Service Bulletin

GL1500 #6
JUNE, 1995

RECALL

ALL MODELS OF 1988-1993 GL1500 BANK ANGLE SENSOR REPLACEMENT

REPAIR PROCEDURE

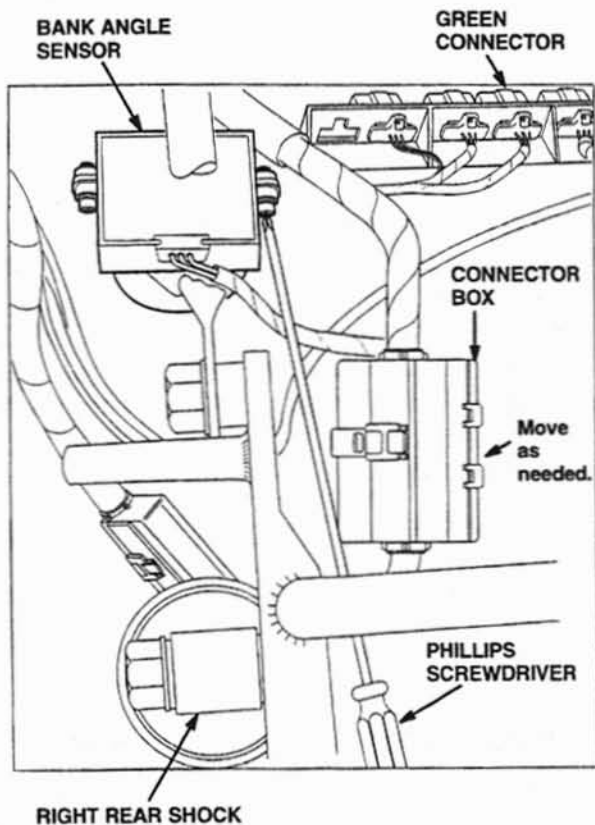
The subject motorcycles are equipped with a bank angle sensor designed to shut off the fuel pump and the engine electrical power in the event the motorcycle overturns or falls down. The sensor uses a weighted pendulum damped by an oil-based liquid to detect banking angles. If the sensor's plastic case material is exposed to high temperature for a prolonged period, it may become unacceptably porous and the damping fluid may permeate the case material. As the quantity of damping fluid decreases, less damping force will be exerted on the pendulum. Abrupt turns or riding over bumpy surfaces might allow a sensor, with below normal damping levels, to shut off the engine unexpectedly. Sudden loss of engine power, especially while turning, may cause a crash.

1. Remove the seat.
2. Move the wire harness and electrical connector box as needed for access to the bank angle sensor screws.
3. Support the back of the sensor mounting bracket; use a long Phillips head screwdriver to loosen the two screws holding the sensor. Then use a magnet to remove the screws.

4. Disconnect the *green* electrical connector.
5. Install the new sensor and connect the *green* connector.
6. If the wire harness and electrical connector box were moved in step #2, reposition and secure them.
7. Install the seat.

Bank Angle Sensor Kit – 1 required
The kit contains one sensor and two 4x20 mm screw-washers.

(The replacement sensor is marked "POM" next to the "UP" mark on the mounting surface.)
